780 BLANSHARD - REHABILITATION + ADDITION

HAV00034 CONCURRENT WITH REZ00825

Bubbled areas indicate revisions compared to the previously submitted plans

DATE	REV	ISSUE DESCRIPTION
2022-02-24	1	REZONING PRE-APPLICATION
2022-06-01	2	OPEN HOUSE PROGRESS SET
2022-06-21	3	REZONING APPLICATION
2023-03-23	4	HAP & REZONING RESUBMISSION

LEVEL 2 FLOOR PLAN

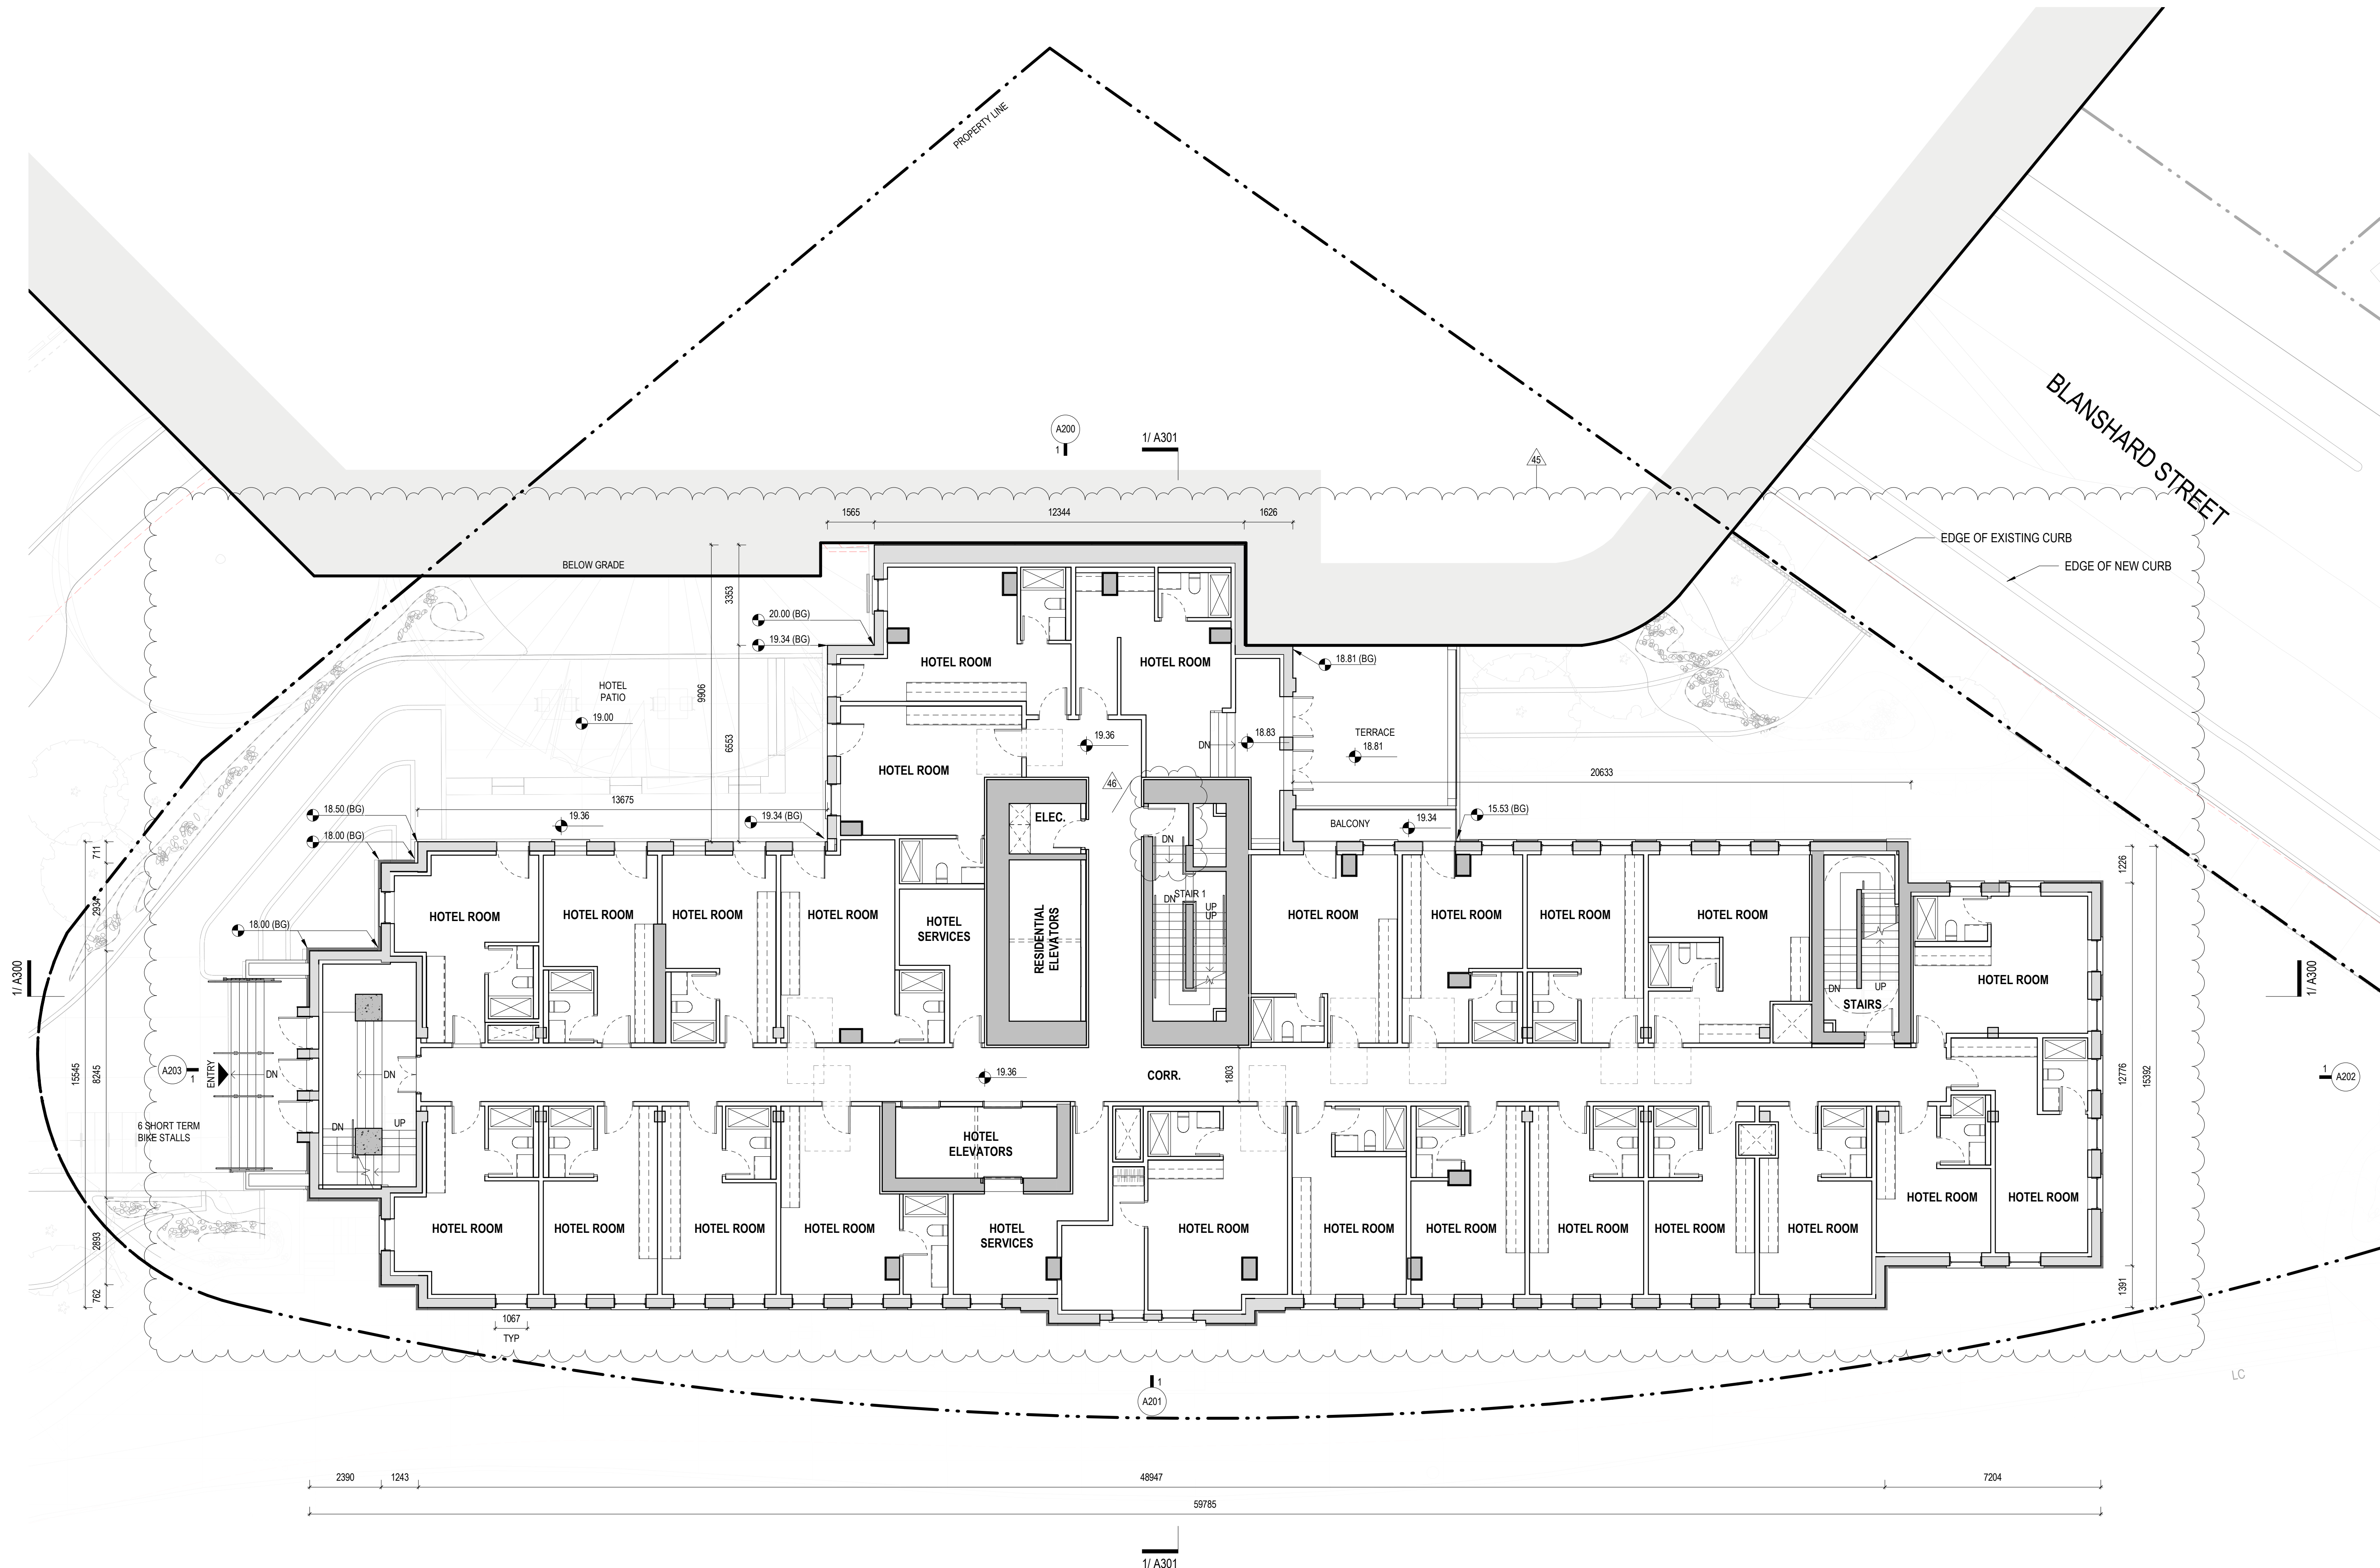
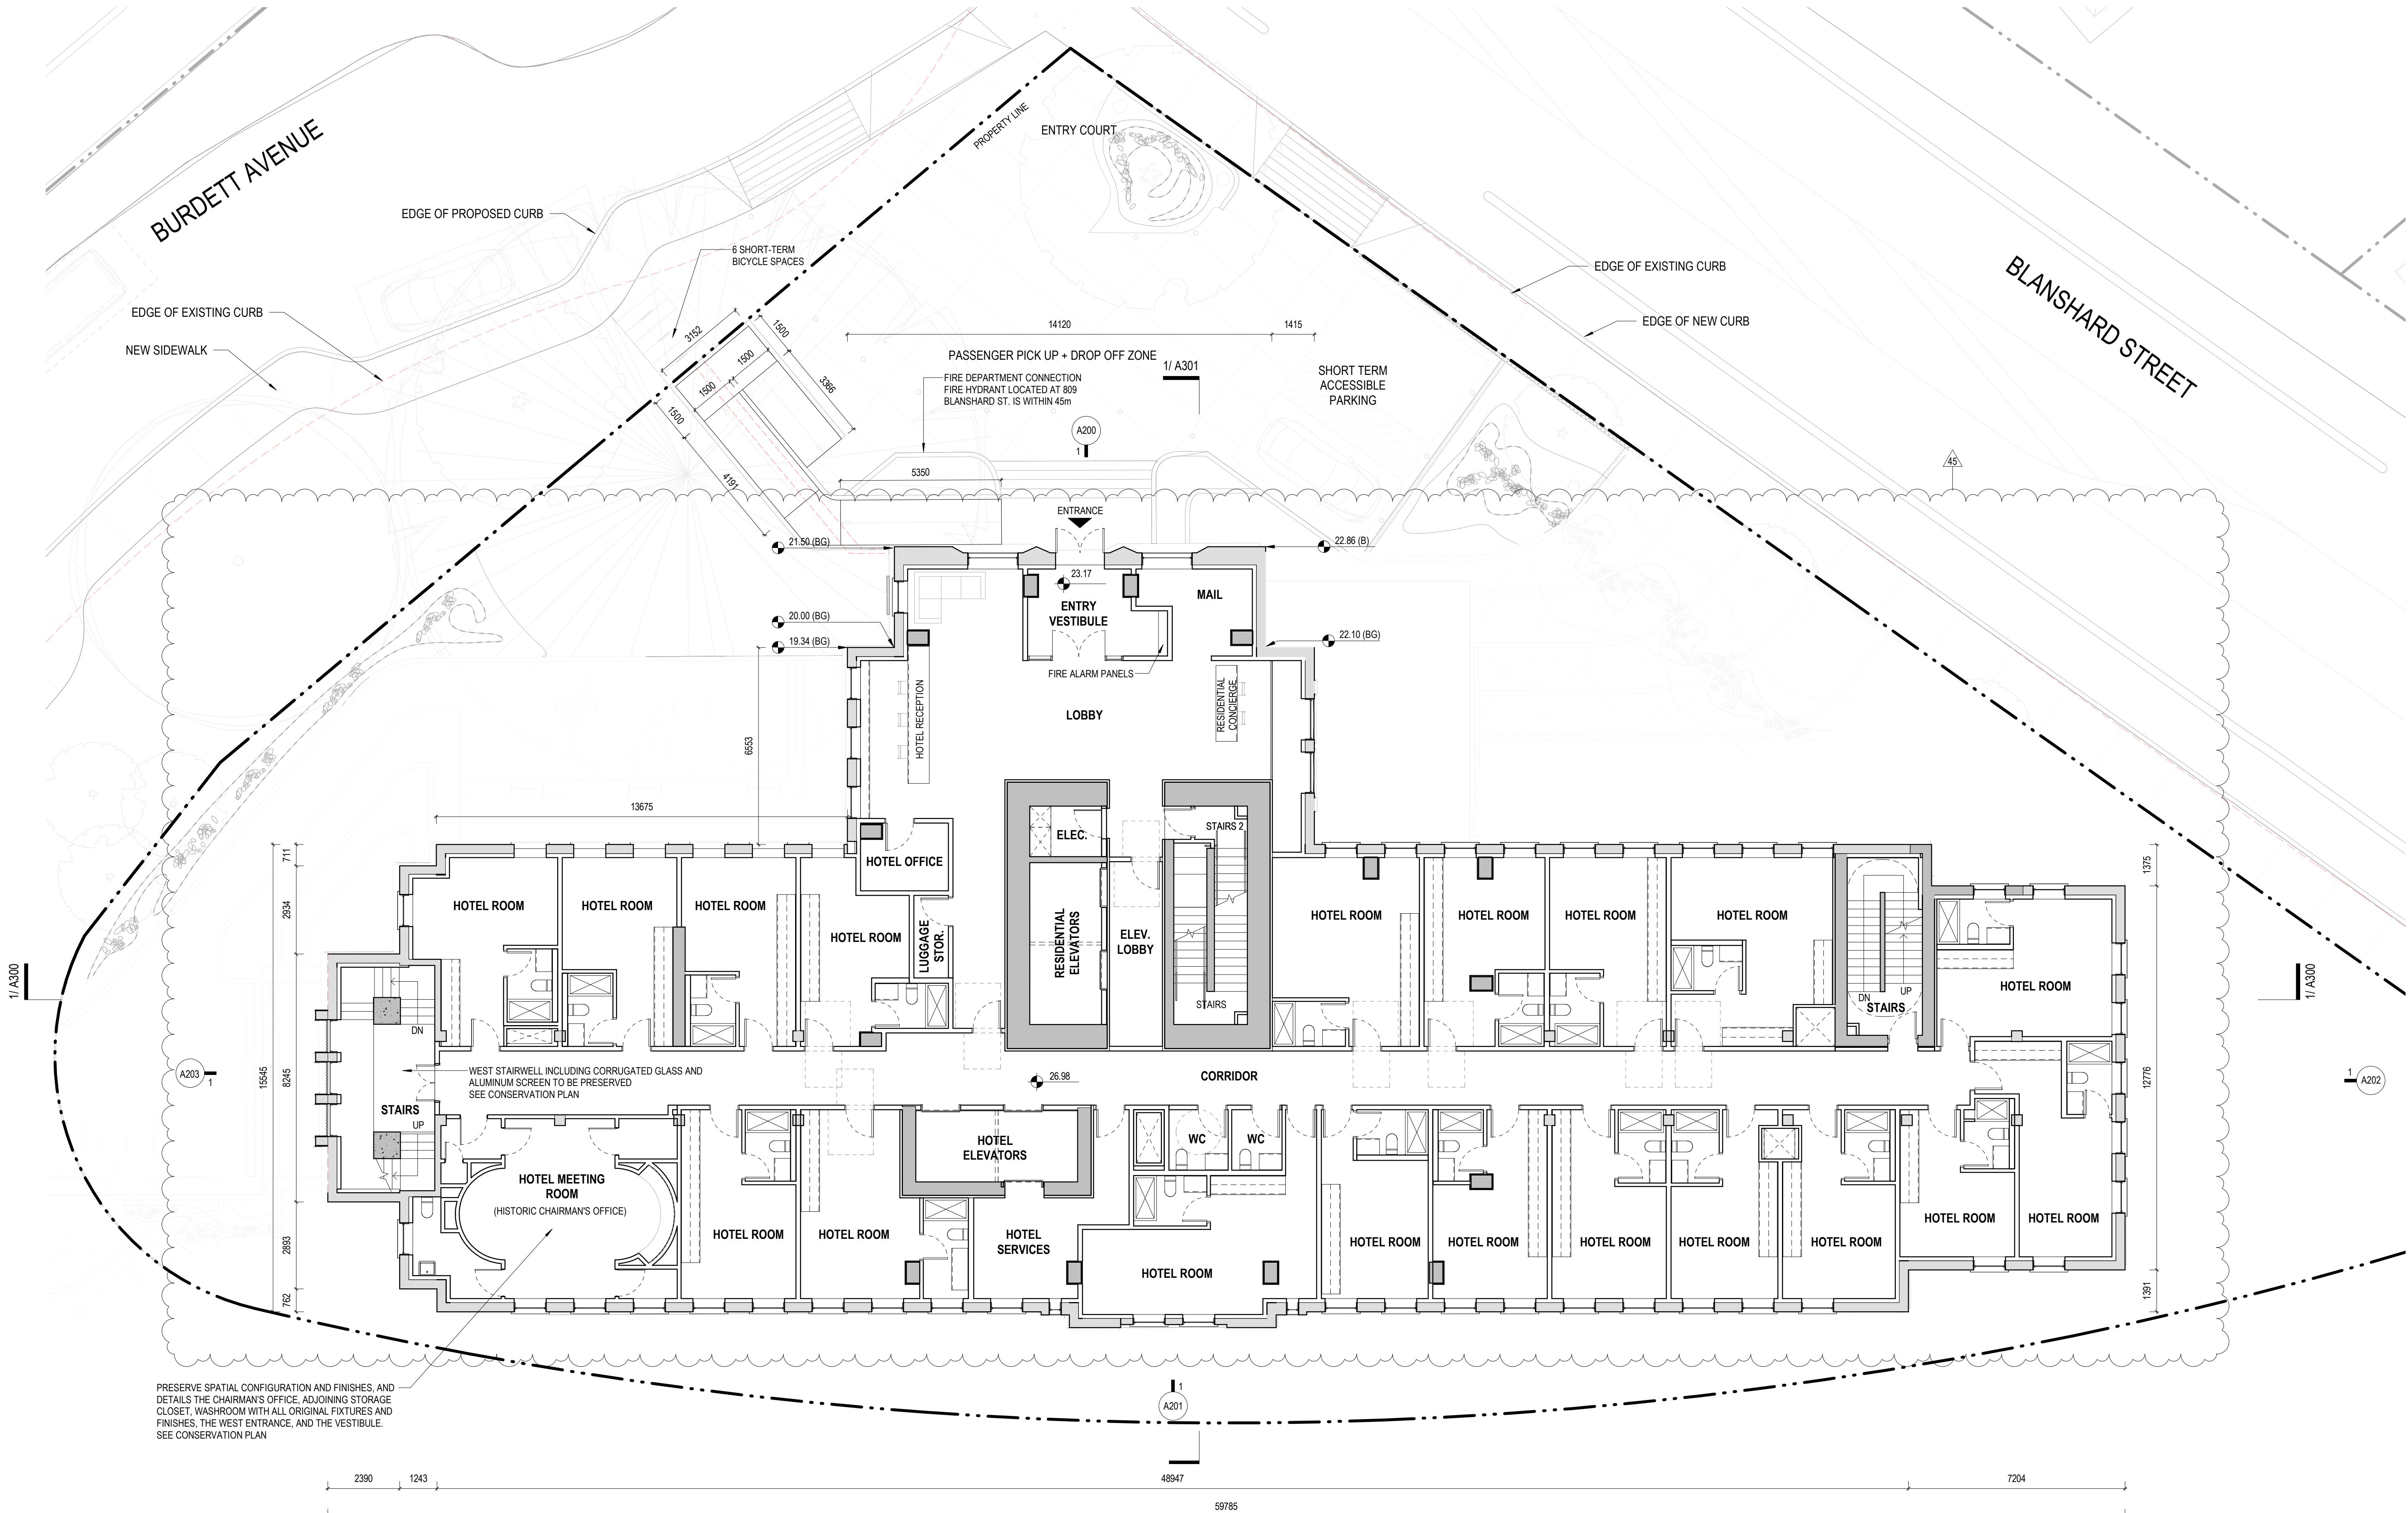
46 To accommodate updated massing and address ARS Comment #114, stair configuration updated so that no flight has two or fewer risers.

LEVEL 4 FLOOR PLAN

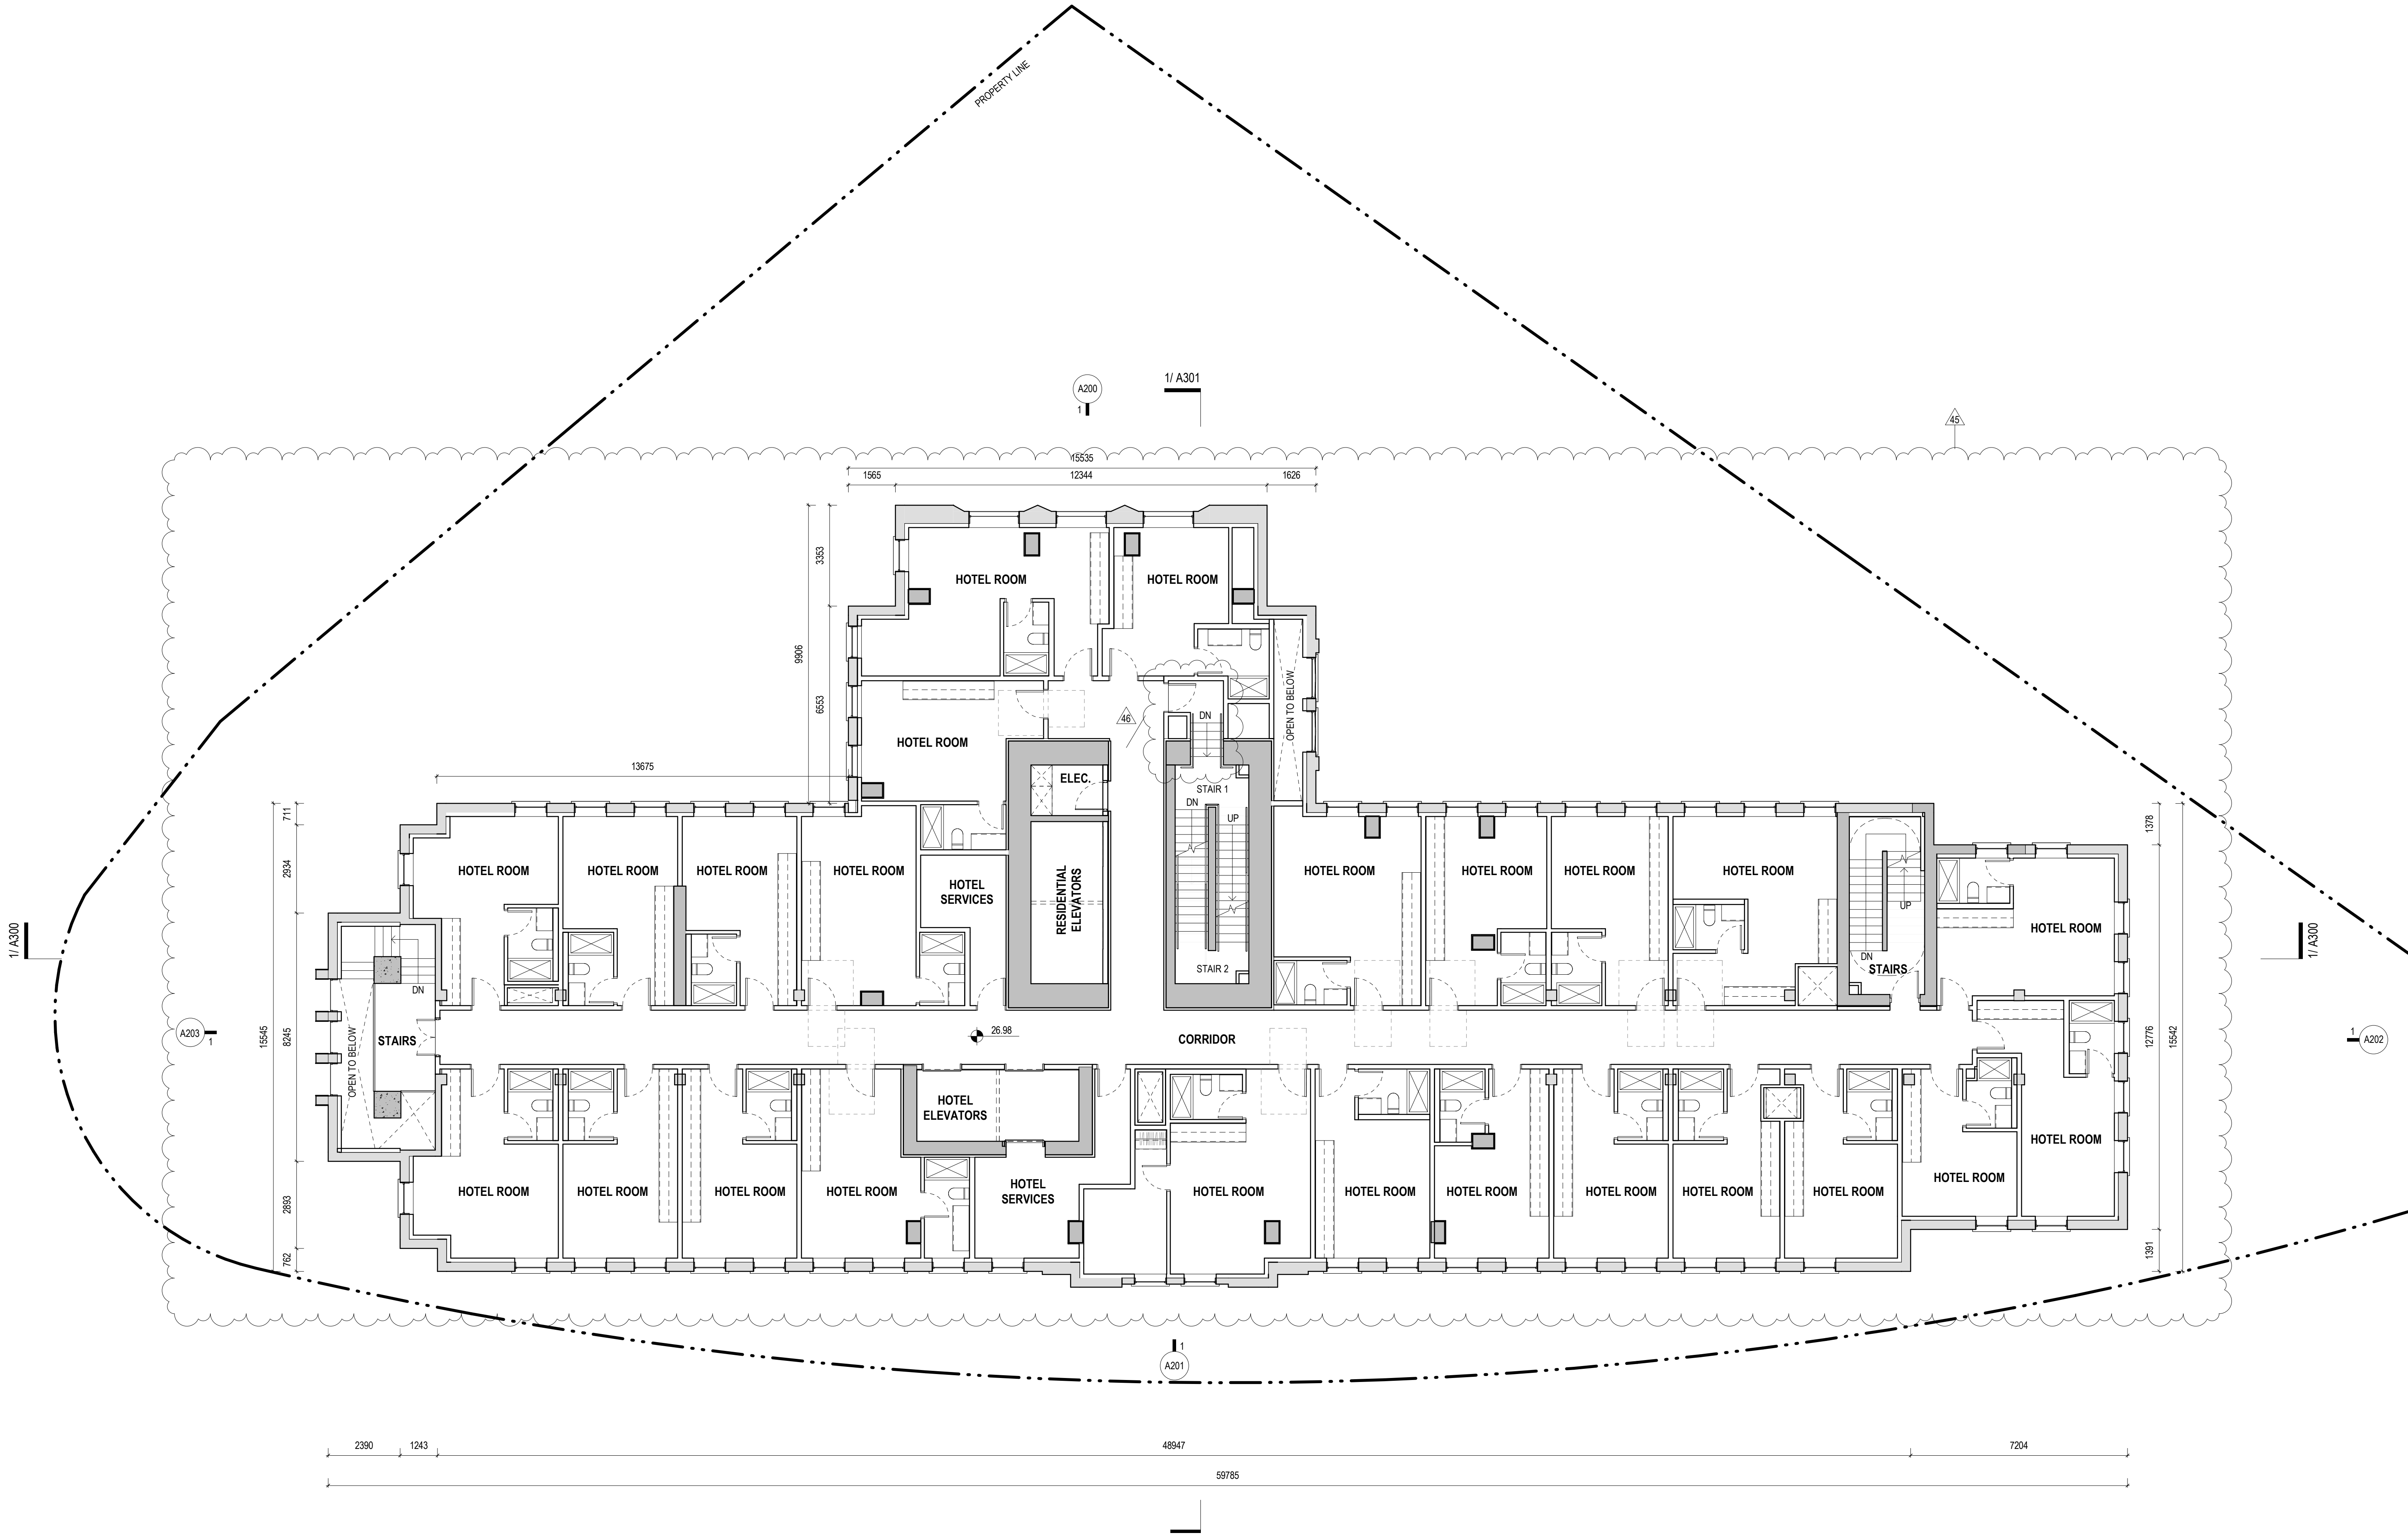
46 To accommodate updated massing and address ARS Comment #114, stair configuration updated so that no flight has two or fewer risers.
